IEEE P802.15 Wireless Personal Area Networks

Project	IEEE P802.15 Working Group for Wireless Personal Area Networks (WPANs)	
Title	TG3 Draft D08 to D09 changes	
Date Submitted	[1 December, 2001]	
Source	[James P. K. Gilb] [Mobilian] [12707 High Bluff Dr., Suite 335, San Diego, CA 92130]	Voice: [858-436-2201] Fax: [858-436-2301] E-mail: [gilb@ieee.org]
Re:	[]	
Abstract	[This document is contains the issues and resolutions developed by the TG3 subcommittee at the Rolling Meadows ad-hoc meeting. It also serves to document the addtions made to the draft standard D08 to produce D09.]	
Purpose	[To provide a record of the resolutions of TG3 and the changes to the draft standard D08 to make D09.]	
Notice	This document has been prepared to assist the IEEE P802.15. It is offered as a basis for discussion and is not binding on the contributing individual(s) or organization(s). The material in this document is subject to change in form and content after further study. The contributor(s) reserve(s) the right to add, amend or withdraw material contained herein.

Desired GTS time, i.e. GTS time per allocation period 35

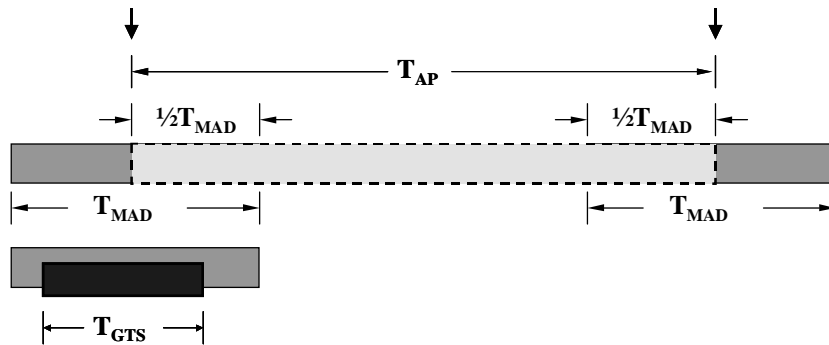
With caveat to add CTRB parameter of desired maximum GTS.

- a) T_{DMG} defines the maximum amount of GTS time per allocation period that a DEV is capable of using. $T_{DMG} > T_{GTS}$ 36
- b) If there is unused bandwidth, the extra channel bandwidth can be divided up among DEVs based on what they can actually use. 37
- c) Allows channel utilization to be maximized. 38

Ed. action: Change the CTRB to match the figure. The new figure and new text are below:

Figure 12—Illustration of the position of T_{MAD} within T_{AP}

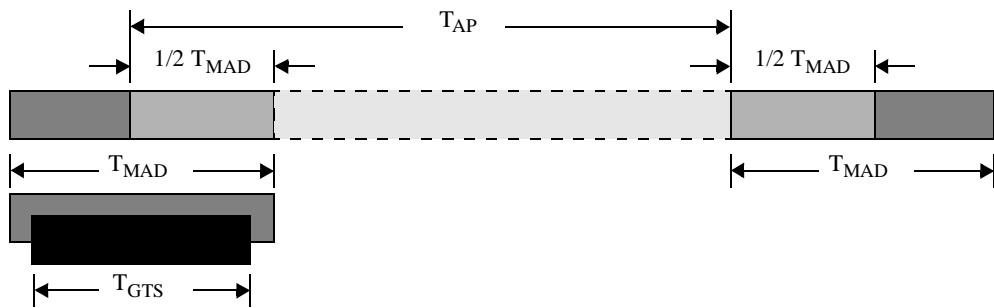
The maximum allocation delay starts before the end of the allocation period, but does not affect the PNC's reference timing of the T_{AP} period. This allows some variability in position of the GTS(s). The DEV determines this time based on the jitter requirements of the data stream that it needs to send. Figure ?? illustrates the position of T_{MAD} within T_{AP} . The T_{GTS} time is the total amount of slot time that needs to be allocated with in the T_{MAD} time centered around the start of the T_{AP} interval.

Figure 13—Possible GTS allocations that meet T_{MAD} requirements

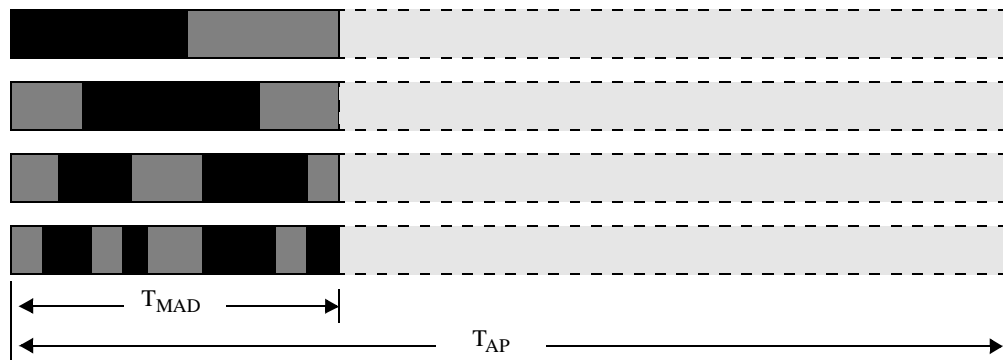
Based on the requirements for T_{MAD} within T_{AP} , the PNC has many possible ways to allocate the GTSs required by the DEV, as illustrated in .
